**RE: INFORMATION REQUEST RESPONSE (SECTION 12 OF THE
DEVELOPMENT ASSESSMENT RULES) & CHANGE TO APPLICATION (SECTION 52 OF
PLANNING ACT 2016)**

**176 BAILEYS MOUNTAIN ROAD, UPPER COOMERA - LOT 183 RP156422, LOT 185
RP173727, LOT 186 RP173728, LOT 56 RP162858, LOT 57 SP214370, LOT 58 SP191940**

- Development Permit – Reconfiguring a Lot (Impact Assessment) for Subdivision (7 into 188 Lots, new road, drainage reserves and open space)

Interface with COM/2024/317

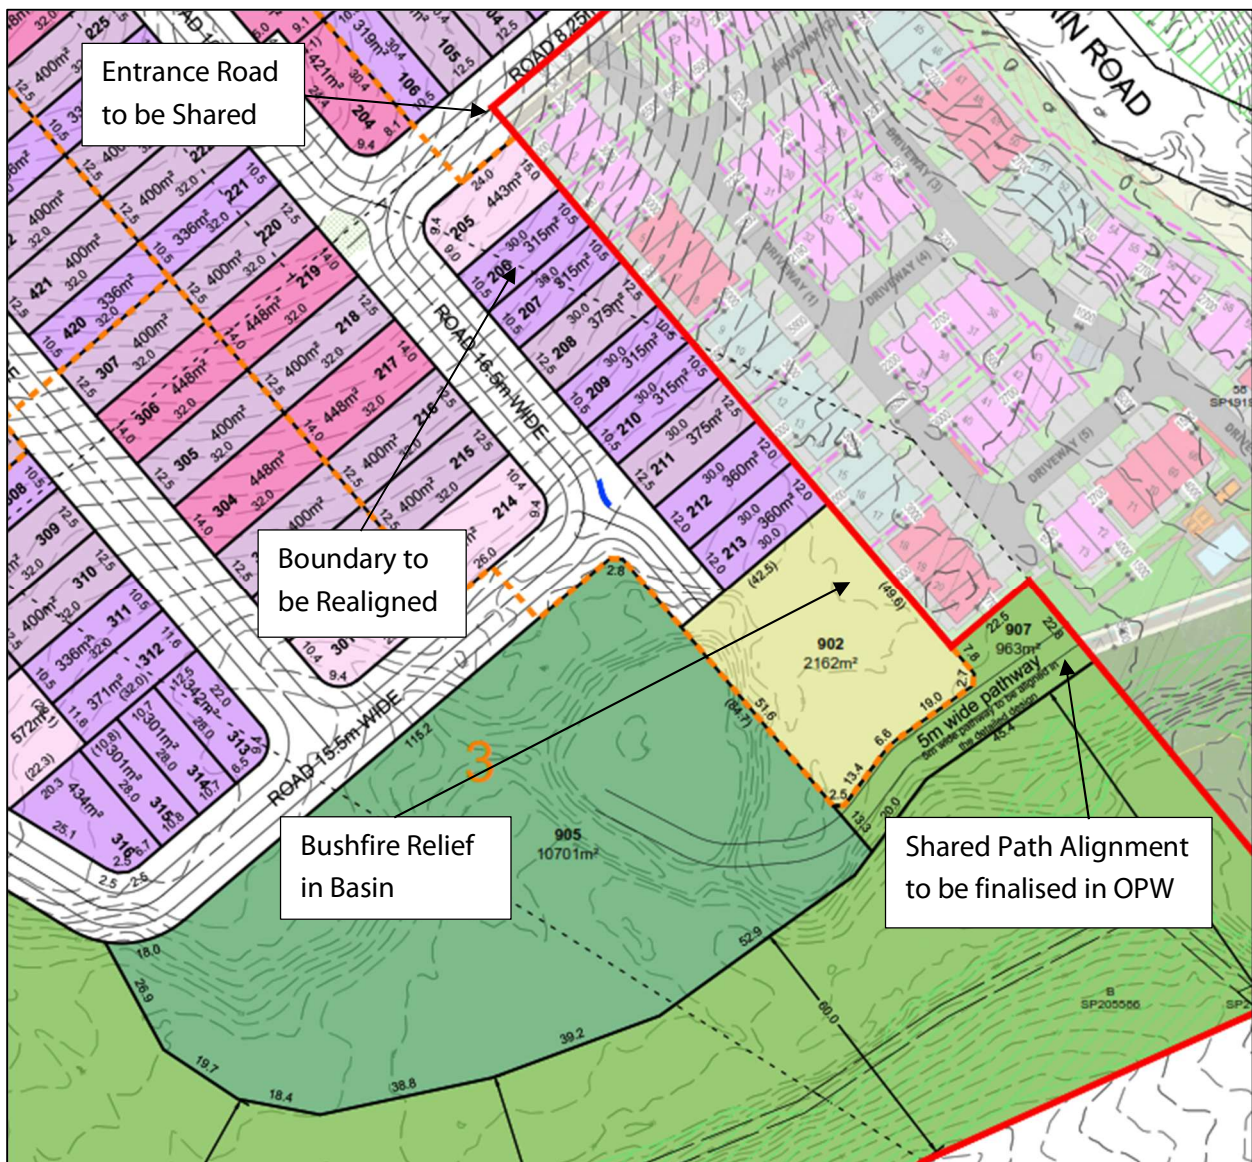
It is noted that Lot 58 SP191940 is included in the subject application. An application is currently being assessed over this site (COM/2024/317), which includes a boundary realignment (to facilitate the subject application) as well as a new road to Baileys Mountain Road and LGIP recreation linkage. The development footprint of the adjacent development and associated infrastructure are to be superimposed on the proposed site plan to show the relationship between the two developments.

The proposal plans have been amended to superimpose the development footprint of COM/2024/317 and show linkage between the two developments. Of note is the requirement of COM/2024/317 to have a bushfire setback which aligns with Lot 902 drainage basin. The southern pedestrian linkage is also of importance and the 5m wide footpath has been roughly aligned with the 30m buffer from the top of Yuan Creek bank. While not exactly aligned on these drawings, conditions of approval will require that at detailed design these are to be matched.

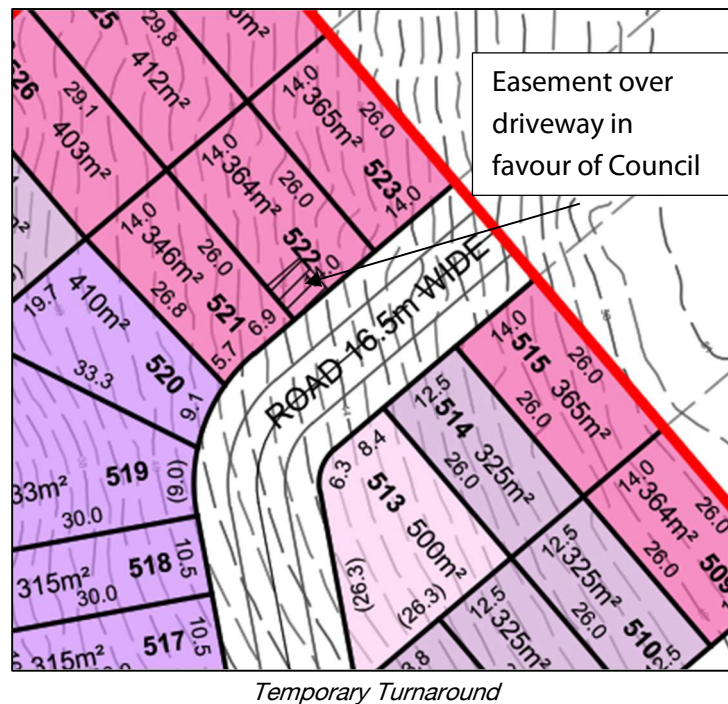
The applicant is requested to demonstrate why five (5) roads with no permanent turn around facility (i.e., cul-de-sac head) are necessary to demonstrate that the future local road network is permeable and facilitates high connectivity in accordance with Specific outcome 3.6.4.1(2) of the Transport system efficiency element of the Strategic framework.

Additionally, as each proposed "temporary turnaround lot" will be private property, the applicant is also required to ensure these areas are burdened by an easement benefitting Council to allow future access for the purpose of vehicle turnaround.

Given the inclusion of 31 Courney Drive, the need for temporary turnarounds has been reduced. However, given the nature of greenfield land development and the fragmentation of land, these scenarios are unavoidable. There are now only 1 temporary turnarounds proposed, which is needed to facilitate development of adjoining parcels of land in an orderly fashion. The inclusion of permanent cul-de-sacs would fragment these parcels and not comply with the walkable neighbourhood provisions of the *Planning Regulation 2017* Schedule 12A.

The applicant's solution is to burden an allotment with an easement and temporary turnaround driveway separate from the dwelling driveway. This temporary driveway can be removed once the road is extended.

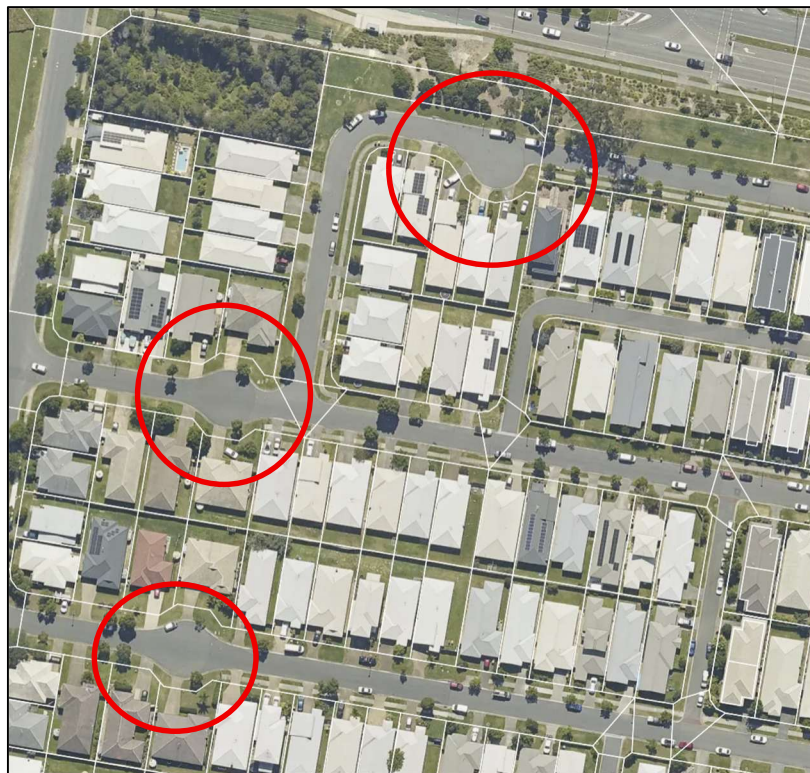
The below image is an example of a poor outcome in Pimpama where cul-de-sacs were created as a temporary solution and can not be remedied. This has resulted in large extents of pavement, reduced verges, irregular lot shapes and reduced on-street parking.

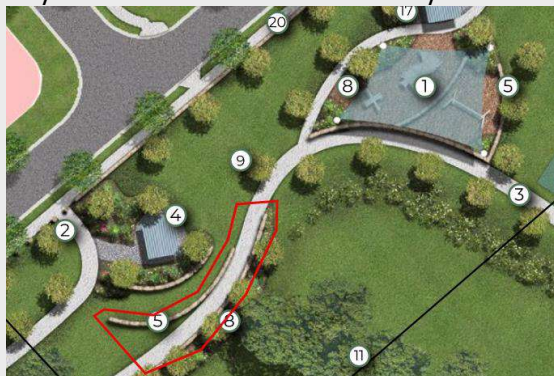
The Preliminary earthworks plans demonstrate a 0-1.5 metre high retaining wall along the frontage of the Park as well as within the Park. The applicant is to ensure that any retaining walls are appropriately identified on the preliminary earthwork plans for consistency.

The Applicant is advised that Officers do not support the proposed retaining walls along the frontage of the path. The retaining walls will impact on the City's ability to carry out maintenance and will also increase future maintenance costs. The Applicant is requested to remove all retaining walls along the frontage of the site. This includes surrounding the proposed pad mount.

The proposed retaining walls have been shown on the updated bulk earthworks drawings (**Attachment F**). 1.5m max retaining walls have been proposed along the frontage of the park to ensure that all proposed batters within the park do not exceed that 1:4. All proposed retaining walls will be a sandstone block wall. See attached Plan of Landscape Intent (**Attachment J**).
